## ASSESSMENT REPORT

## Taralga Wind Farm – Modification 8

TWF is seeking further modifications to its consent (DA241/04 MOD 8). There are 6 components to the proposed modification, including:

**Figure 3: Proposed Re-transmitter Locations and Receive Antenna**

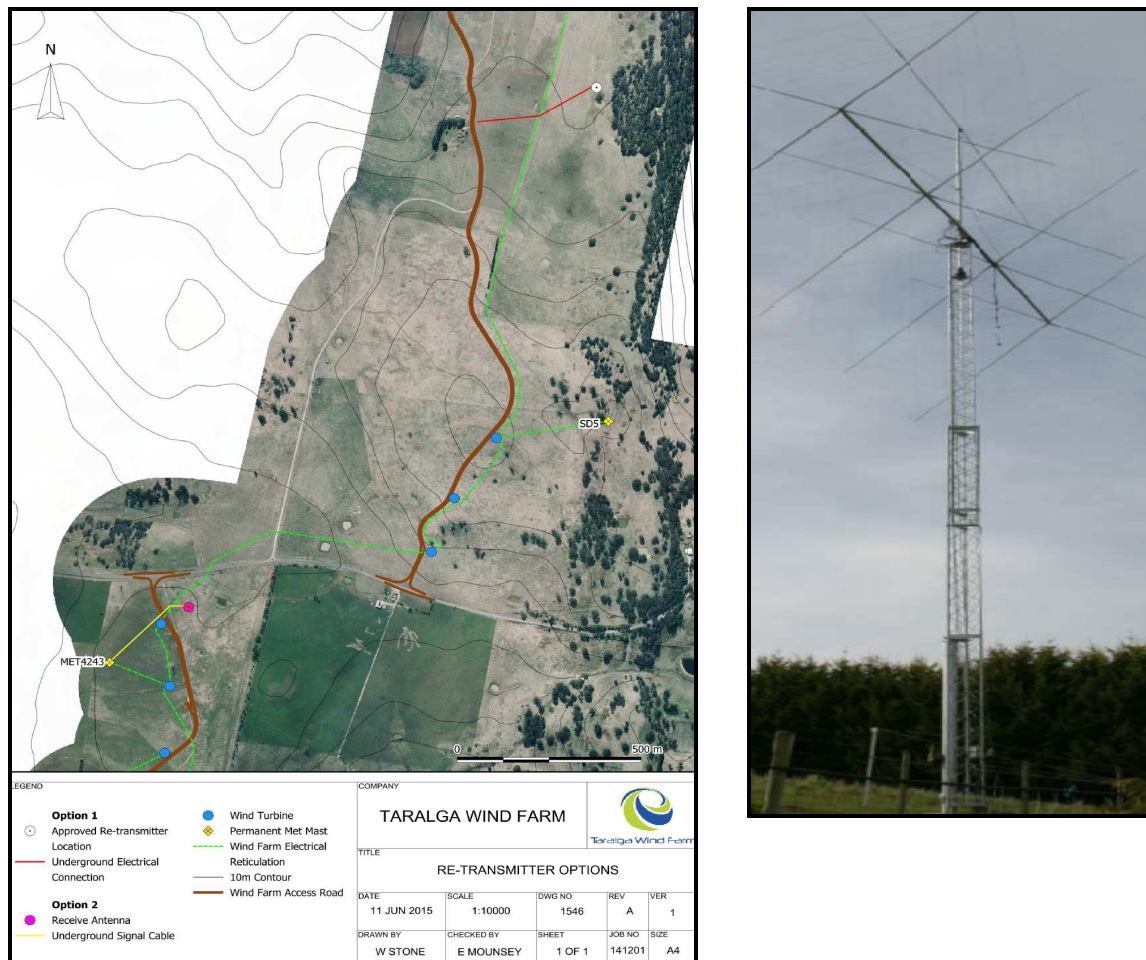
However the consent did not include reference to the necessary low voltage power connection for the re-transmitter. TWF has asked that this now be included in the project, and for an alternative location to be considered to locate the re-transmitter (see also Figure 3).

Both options require around 300 m of underground cable to connect the re-transmitter to a local power supply. Whichever option is selected, this infrastructure is unlikely to materially increase the approved biodiversity impacts of the project, given the land is cleared grazing land containing non-native vegetation. The Department also considers that this infrastructure would not increase the approved visual impacts of the project, given the scale of the antenna (see Figure 3), and particularly so for Option 2, as this option involves attaching the re-transmitter to an existing meteorological mast located in close proximity to 3 turbines.

The Department is also satisfied that the minor nature of this infrastructure, its low-voltage power connection and the distances between the proposed locations and residences, that electro-magnetic field impacts are unlikely to exceed recommended guideline levels.

Overall, the Department does not object to either option being used for this equipment, and considers that the current conditions of approval would effectively manage any residual installation or operational impacts.
